PLANNING COMMISSION MEETING AGENDA REGULAR MEETING

January 8, 2013

5. PUBLIC HEARING – CONDITIONAL REZONING APPLICATION (File Number CR 008) – Proposed Tim Horton’s Café, Northwest Corner Square Lake and Dequindre, Section 1, From NN (Neighborhood Node “N”) to CB (Community Business) District

Conditional Rezoning, Special Use Permit and Preliminary Site Plan Review For City of Troy, Michigan

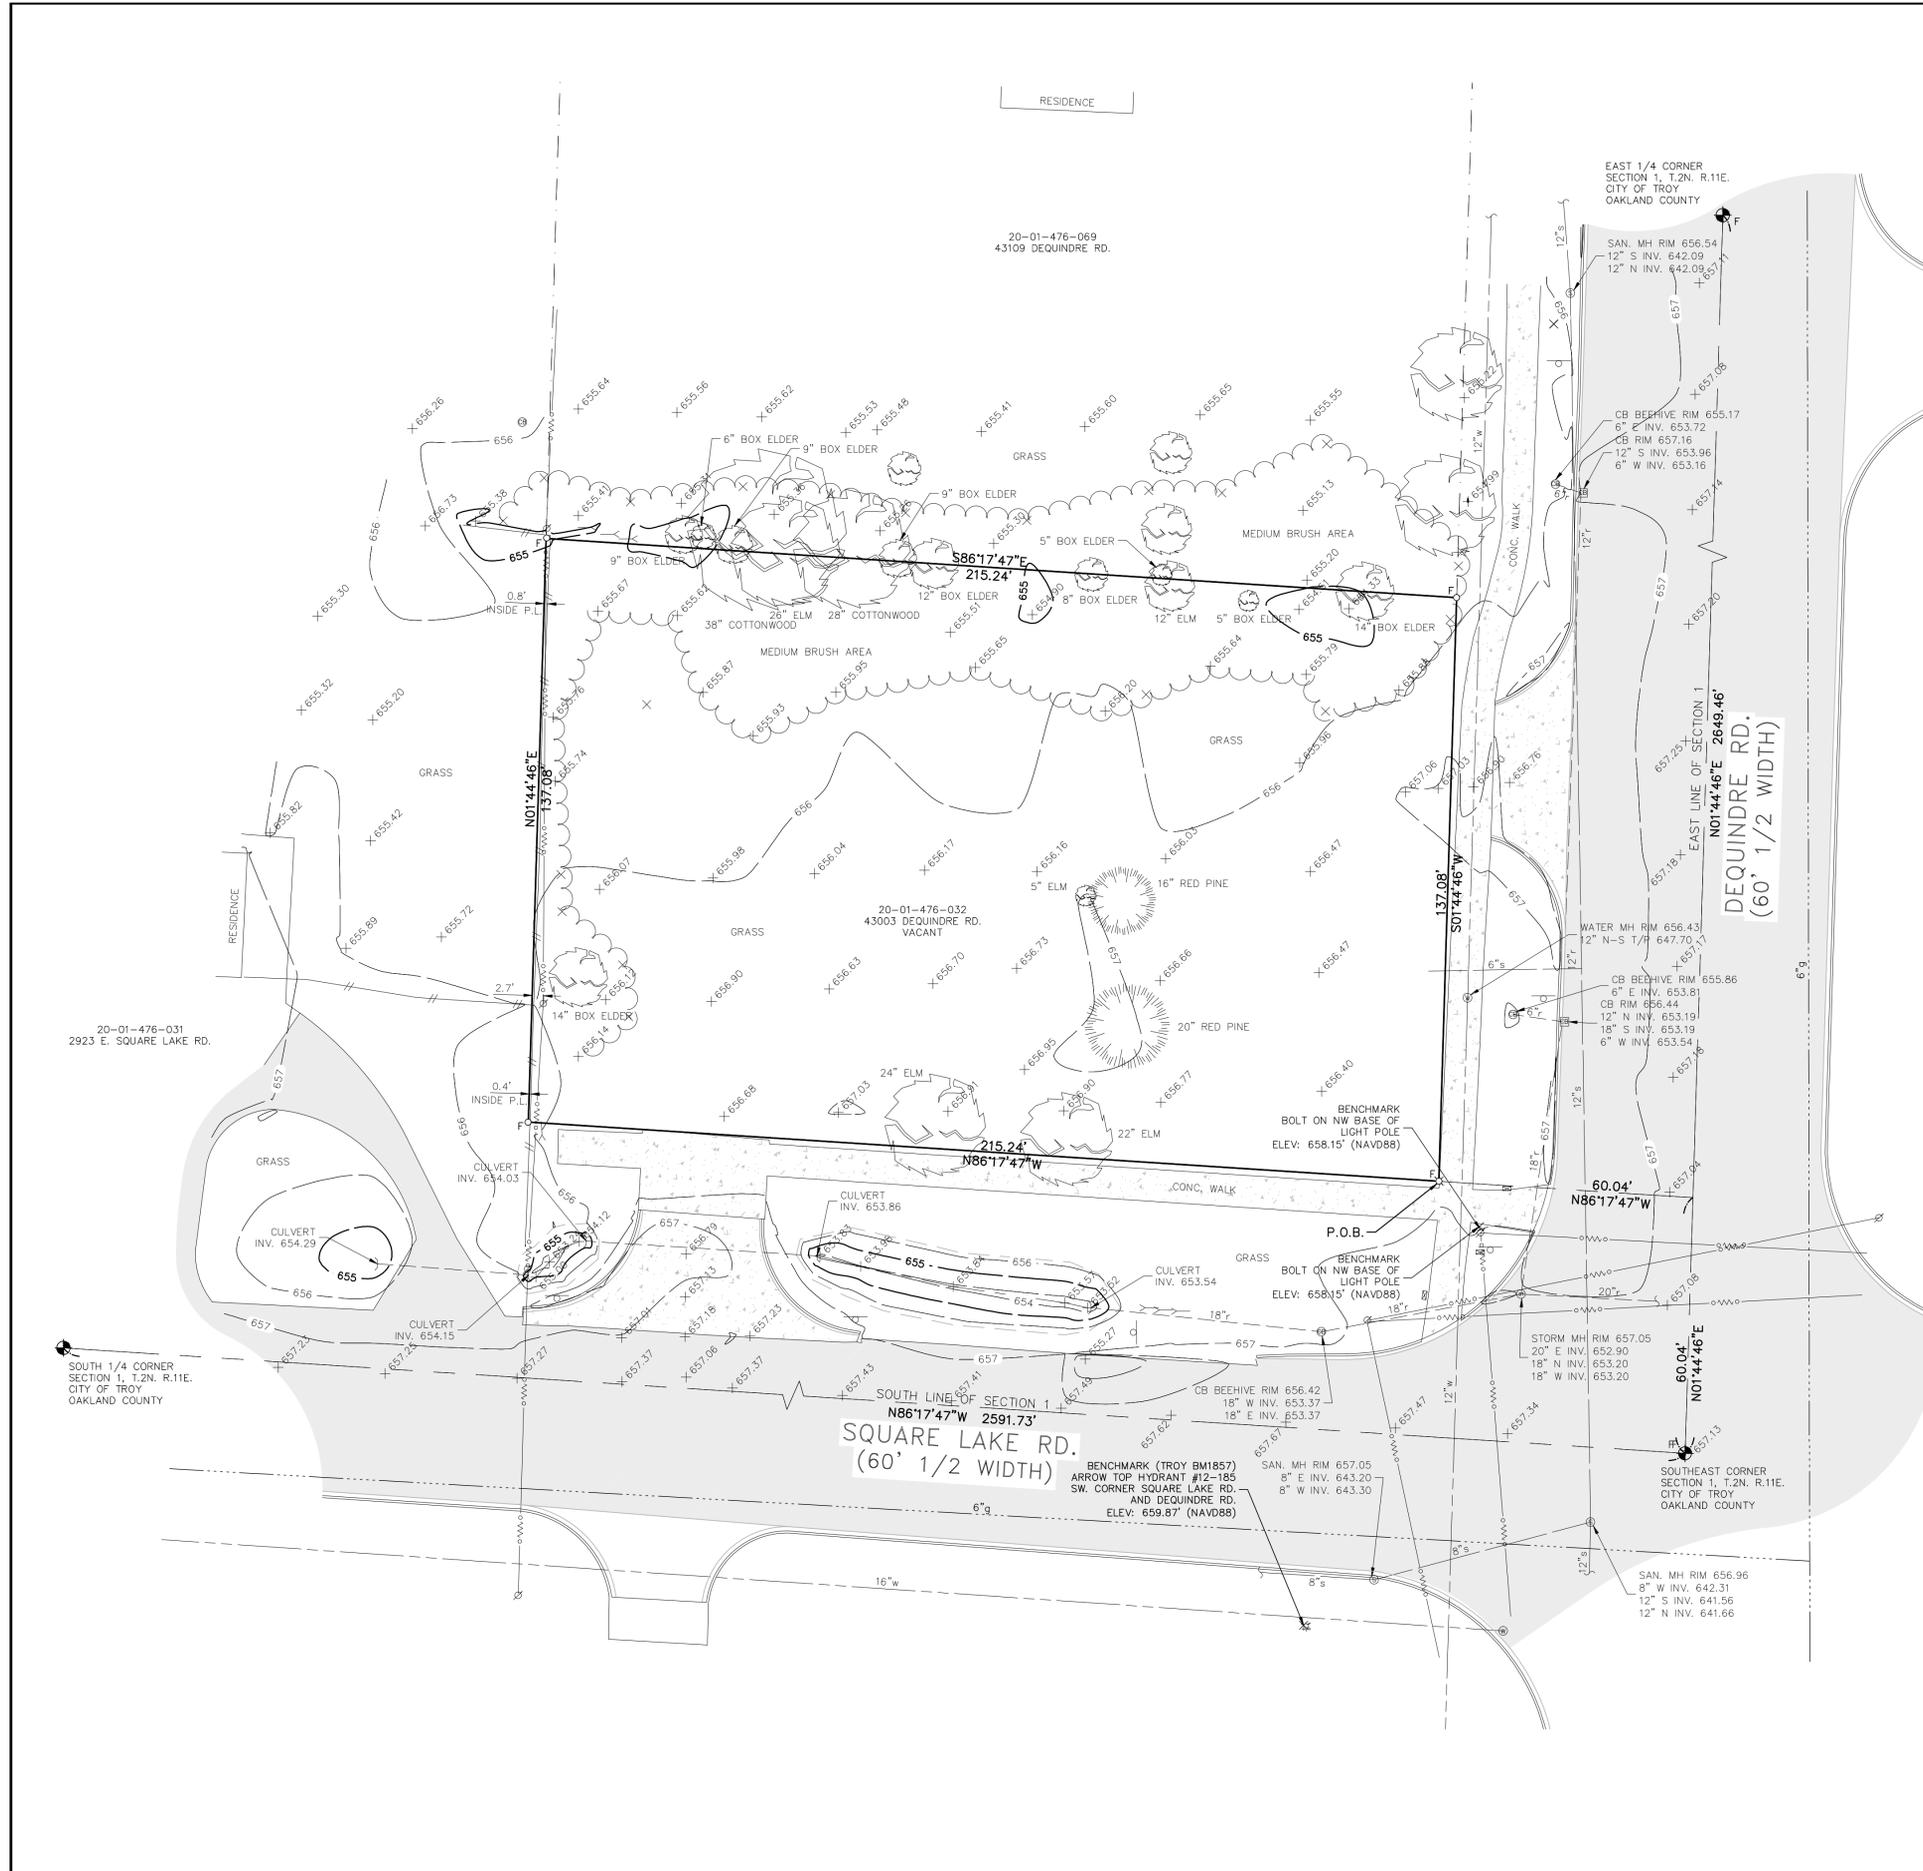
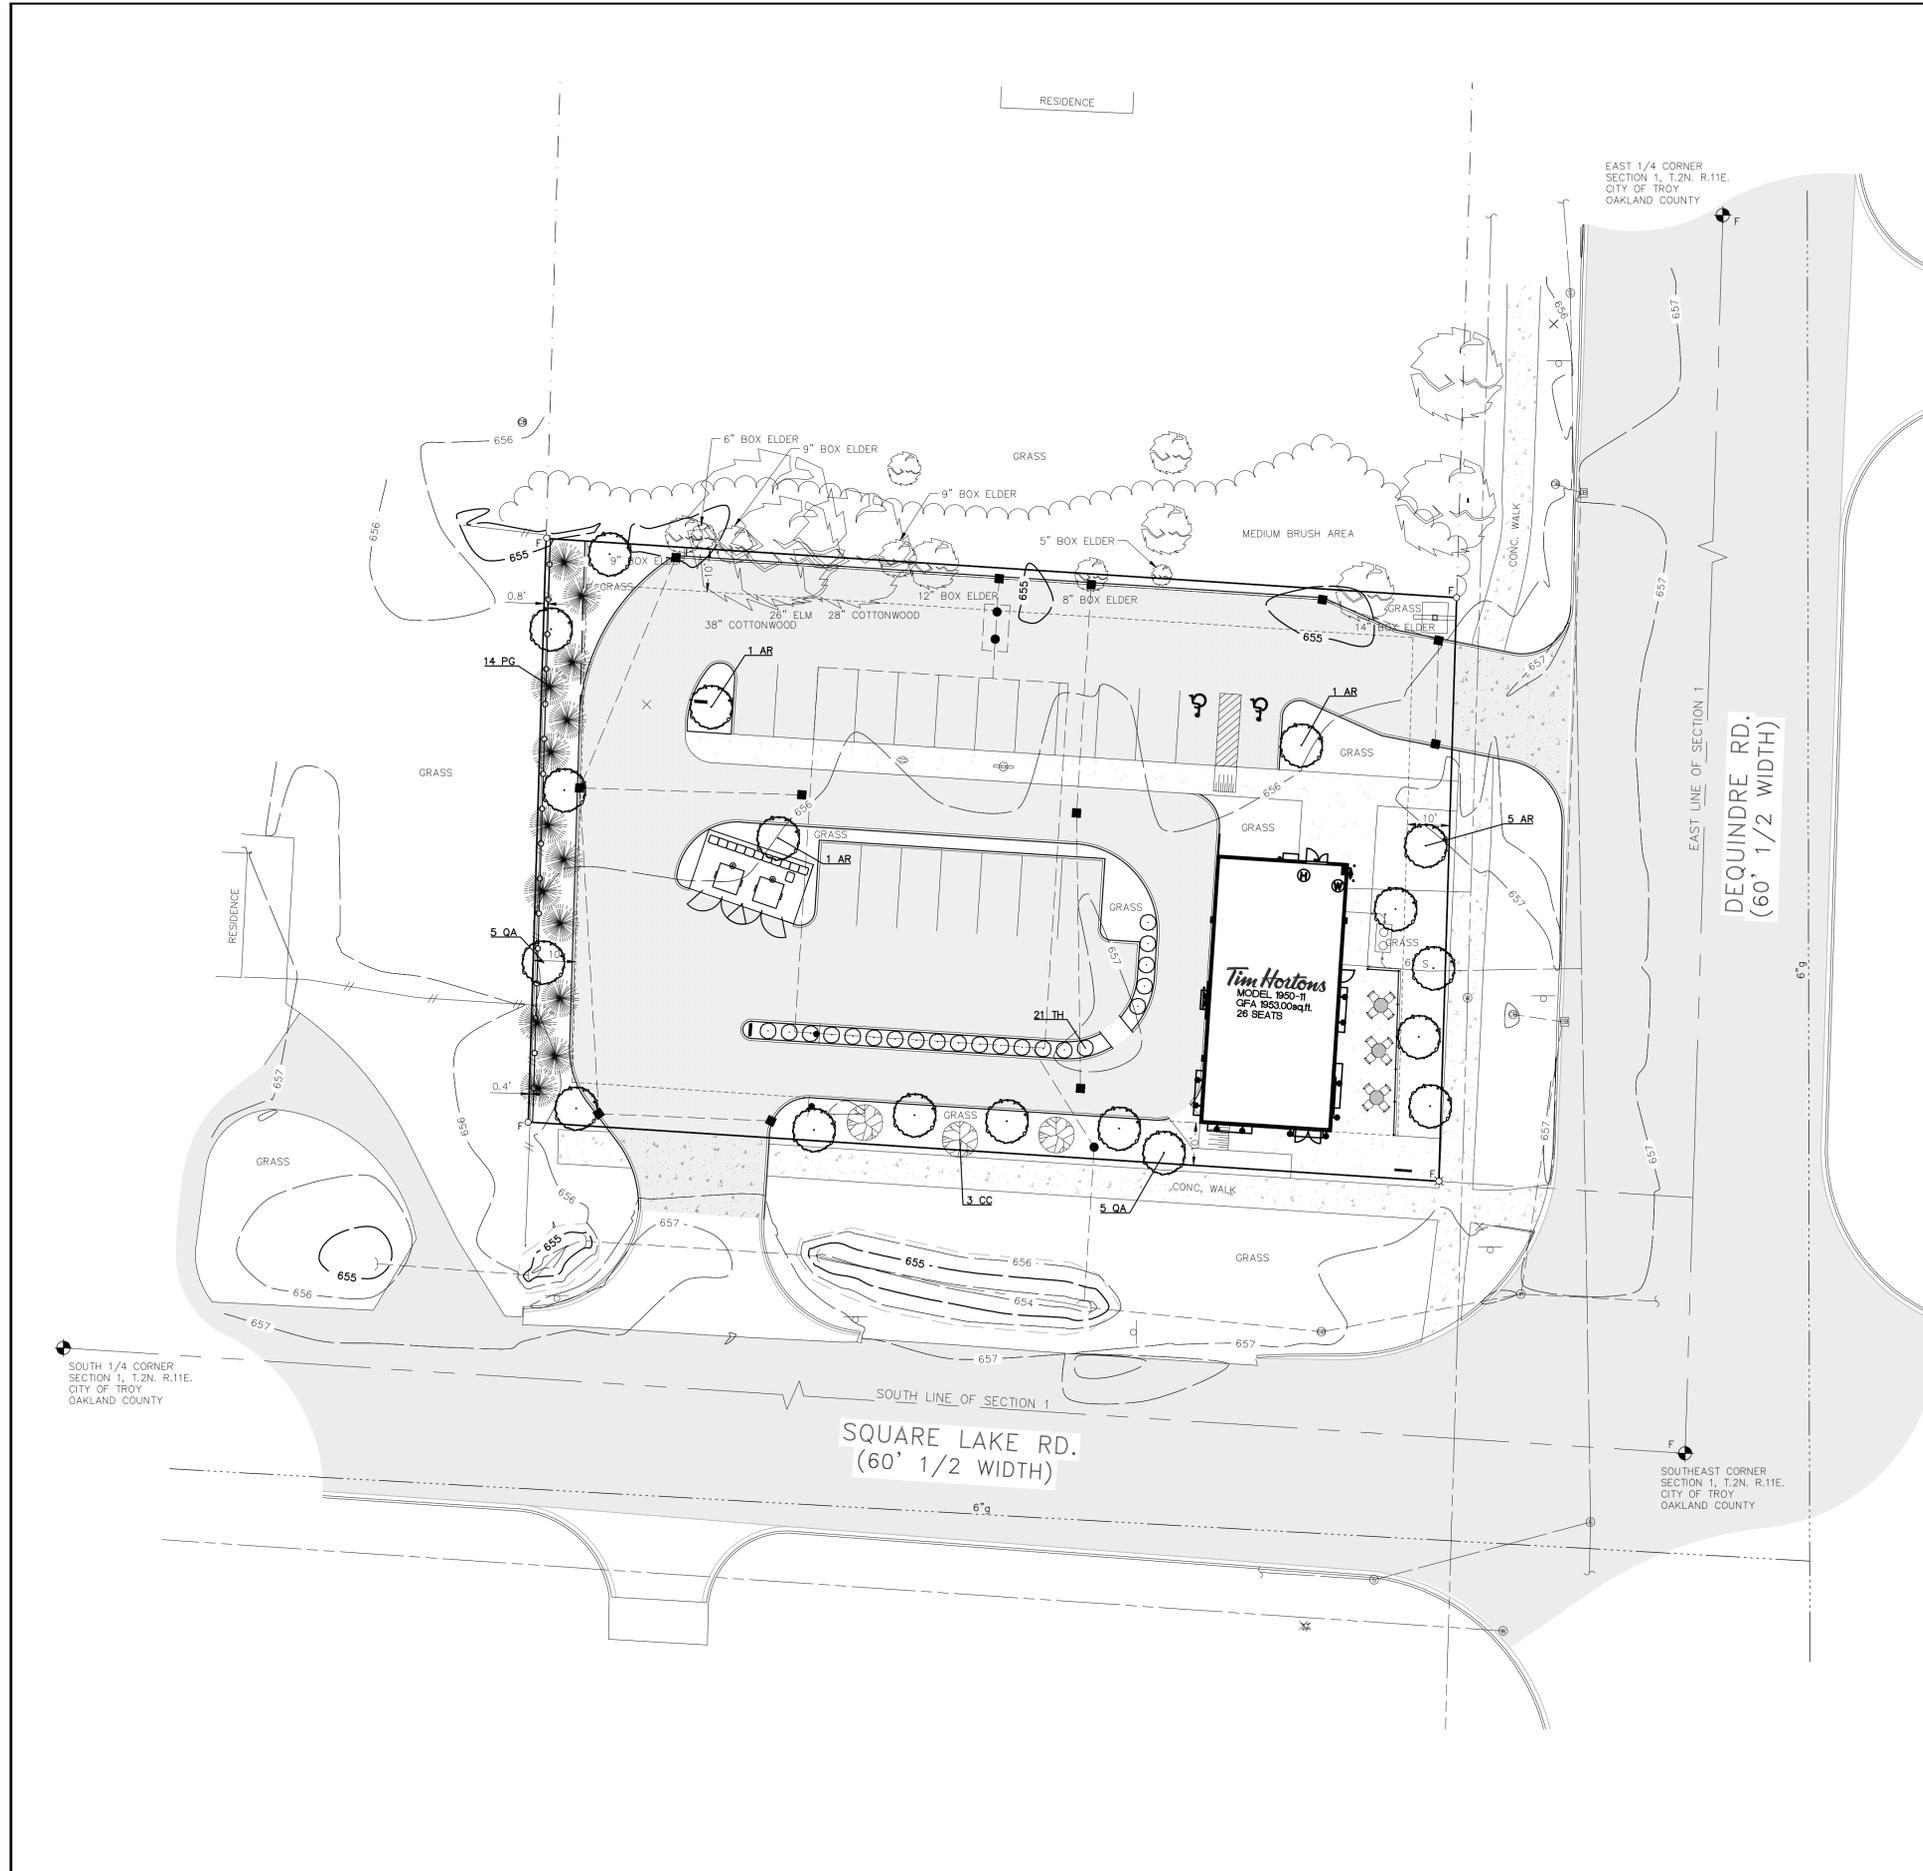
Parking, traffic, and circulation for this site must be carefully examined. The Engineering Department has requested a traffic study to review the need for a deceleration lane on Square Lake, internal circulation, and potential for restricting left turns in and out of the site. The other Tim Horton locations that have been built in Troy have been on higher volume roads including Big Beaver and Rochester (both 6-lane boulevards) and Maple (5-lane road which required that they provide a right turn lane or at least infill the one that stopped short of the existing site). In addition, Dequindre is a County border road, so any work in the Dequindre ROW or impact from the development on Dequindre may need input/permits from Sterling Heights/Macomb County/Oakland County.

Access to the site will be via a curb cut off Square Lake and a curb cut off Dequindre. The Engineering Department notes that both approaches are irregularly shaped. The applicant should try to reconfigure the approaches so that they enter the property perpendicular to the property line and then provide the necessary radii to match up to the parking lot. This would result in a more typical parking lot layout.

The applicant is deficient by eight (8) parking spaces. The Planning Commission may reduce the required parking provided that the applicant provide evidence that such parking is not necessary. The approved Maple Road Tim Hortons was exactly the same square footage and provided 22 spaces.

The applicant did not provide a Photometric Plan, as required.

Based on a 0.68 acre site, the applicant is required to provide 592 sq/ft of landscaped area. The applicant should confirm if they have met this requirement. The applicant should indicate on site plan where snow storage is proposed. Lastly, the applicant should provide trash enclosure details; the applicant is encouraged to match the enclosure materials with the masonry of the building.

Items to be Addressed: 1). Provide traffic study prior to Planning Commission recommendation of Conditional Rezoning and Preliminary Site Plan approval; 2). Reconfigure the approaches so that they enter the property perpendicular to the property line; 3). Reduce drive-through width to 10 feet; and 4). Reconfigure layout so that the tenth required stacking space does not protrude into drive-aisle.

Items to be Addressed: Provide 8 additional spaces, or provide evidence that providing only 18 spaces is sufficient to address site parking needs.

Items to be Addressed: Provide a Photometric Plan in compliance with Article 13.

Items to be Addressed: 1.) Provide overall landscaping calculation; 2.) Replace ornamental trees with deciduous ones along Square Lake; and 3.) Provide one (1) additional parking lot tree; 4.) Indicate on-site snow storage; and 5.) Provide trash enclosure detail.
